SUBJECT: SURRY UNITS 1 AND 2 - ISSUANCE OF AMENDMENTS RE: INCREASED ENRICHMENT OF RELOAD FUEL (TAC NOS. MA0122 AND MA0123)

AMENDMENT NO. 214 TO FACILITY OPERATING LICENSE NO. DPR-32 - SURRY UNIT 1
AMENDMENT NO. 214 TO FACILITY OPERATING LICENSE NO. DPR-37 - SURRY UNIT 2

SAFETY EVALUATION BY THE OFFICE OF NUCLEAR REACTOR REGULATION
RELATED TO AMENDMENT NO. 214 TO FACILITY OPERATING LICENSE NO. DPR-32
AND AMENDMENT NO. 214 TO FACILITY OPERATING LICENSE NO. DPR-37

SURRY POWER STATION, UNIT NOS. 1 AND 2

FIGURE 5.4-1

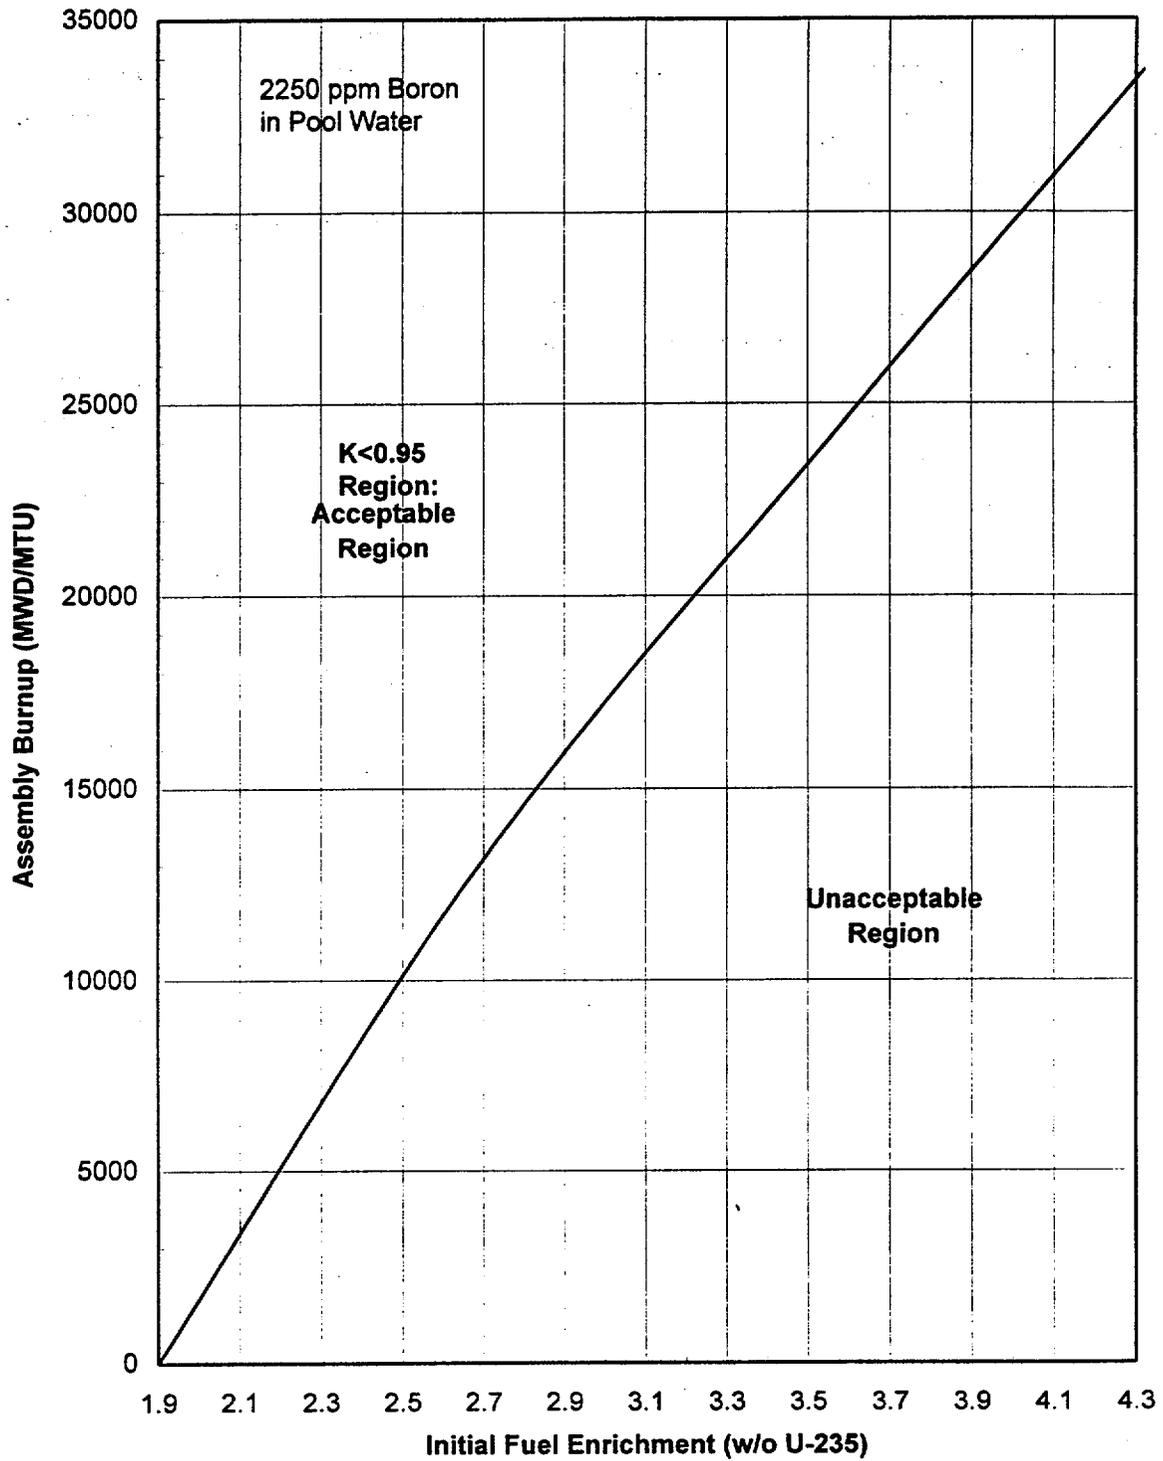
- 2) TS 5.4.B has been changed to increase the maximum enrichment of the fuel which may be stored in the spent fuel racks from 4.1 to 4.3 w/o U-235.
- 3) TS Figure 5.4-1 has been changed to allow fuel enriched to 4.3 w/o U-235 to be stored in Region 1 with burnup restrictions and 2250 ppm of boron in the pool water.

The Region 1 racks, fully loaded with fuel enriched to 1.9 w/o U-235 and damaged as a result of a cask drop accident, resulted in a pool k_{eff} of 0.93204, including all applicable uncertainties and tolerances, with 2250 ppm of soluble boron in the pool water. To allow the loading of fuel with maximum enrichments up to 4.3 w/o U-235 in Region 1 of the Surry spent fuel pool, credit was taken for the fuel burnup using the standard reactivity equivalencing methodology approved by the NRC. In this case, fuel assemblies stored in Region 1 must satisfy the minimum burnup versus initial enrichment requirements specified in the proposed TS Figure 5.4-1, which shows that fuel initially enriched to 4.3 w/o U-235 must achieve a burnup of approximately 33,000 MWD/MTU. TS 5.4.B requires that administrative controls with written procedures be employed in the selection and placement of these assemblies.
